Access Compliance Report

Public Rights-of-Way

Intersection ID: 31296	Main Street: DEERTON_RD	Cross Street: MELSTRAND_WY	Location: S
ADA ID: 2FD018C2F68E	Ramp Type: PerpDiag	Initial Pass/Fail: Fail	Overall Compliance: No
Severity Score: 58.75			
Codes/Mitigation Info/Possible Solution		Field Measurements/Component Compliance

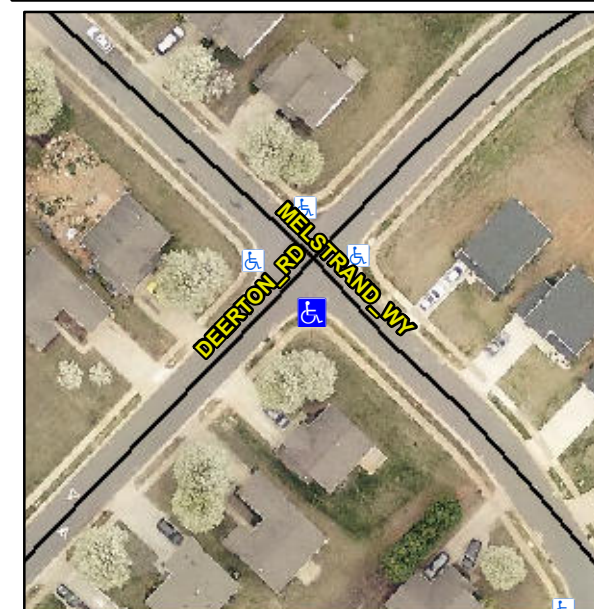
Remove & Replace Curb Ramp With Two New Directional Ramps or Equivalent.

R304.5.1, R304.2.2, R304.5.3

Compliance	Description	Data	Compliance	Description	Data
N/A	Ramp Length (in)	55.0	No	Ramp Slope (%)	12.4
No	Ramp Width (in)	39.0	No	Ramp XSlope (%)	9.4
N/A	Flare Type LT	N/A	N/A	Flare Type RT	N/A
N/A	Flare Slope LT (%)	N/A	N/A	Flare Slope RT (%)	N/A
N/A	Flare Traversable LT?	N/A	N/A	Flare Traversable RT?	N/A
N/A	Landing Length (in)	N/A	N/A	DWS Provided?	N/A
N/A	Landing Width (in)	N/A	N/A	DWS Contrast?	N/A
N/A	Landing Slope (%)	N/A	N/A	DWS Length (in)	N/A
N/A	Landing X Slope (%)	N/A	N/A	DWS Full Width?	N/A
N/A	Landing Curb? (Y/N)	N/A	N/A	DWS Offset (in)	N/A
N/A	Shared Landing?	N/A			
N/A	Gutter Ponding?	N/A	N/A	Gutter Slope (%)	N/A
N/A	Gutter Lip Ht (in)	N/A	N/A	Gutter X Slope (%)	N/A
N/A	Painted X Walk1?	No	N/A	Painted X Walk2?	No
	X Walk 1 Direction	To NE		X Walk 2 Direction	To NW
N/A	X Walk 1 Width (in)	N/A	N/A	X Walk 2 Width (in)	N/A
	X Walk 1 Slope (%)	3.1		X Walk 2 Slope (%)	7.4
	X Walk 1 X Slope (%)	7.6		X Walk 2 X Slope (%)	5.5
